Appendix A: Technical Evaluation of the Denver Water Lead Reduction Program Plan

Why is the Denver Water variance at least as efficient in lowering lead levels as the LCR and LCRR?

Figure 3: 90th percentile lead levels in tap samples in the Denver Water distribution system since 1997

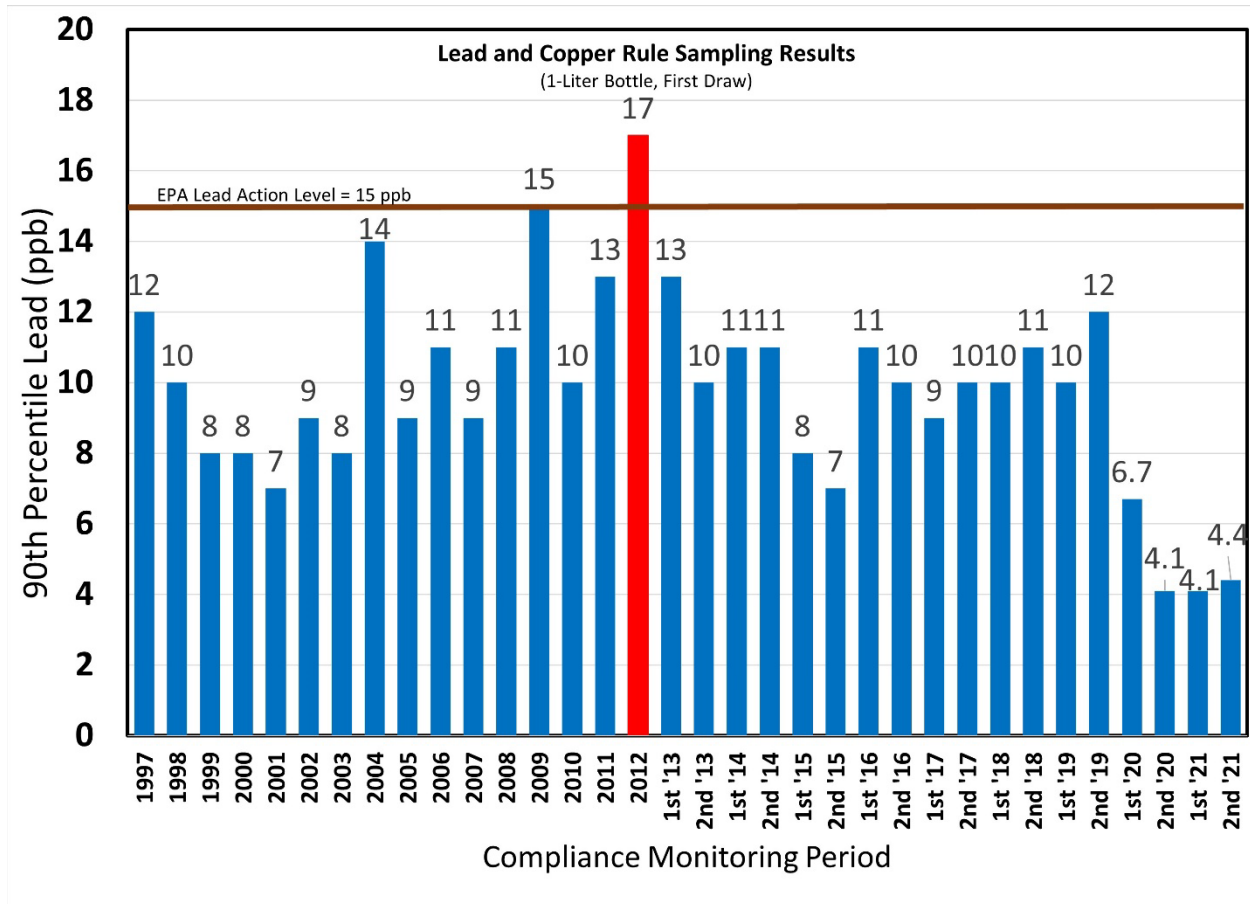
The 90th percentile lead levels in tap samples in the Denver Water distribution system have consistently been below the lead action level since 1997 with the exception of an exceedance in 2012, as shown in Figure 3 below. The first two years of data have also shown that lead levels were further reduced by pH and alkalinity adjustment as CCT. Denver Water's most recent 90th percentile lead level at the end of 2021 was 4.4 ppb. At properties with LSLs, the 90th percentile level was 4.5 ppb and at properties with copper plumbing and lead solder the 90th percentile was 2.3 ppb for this same compliance period.
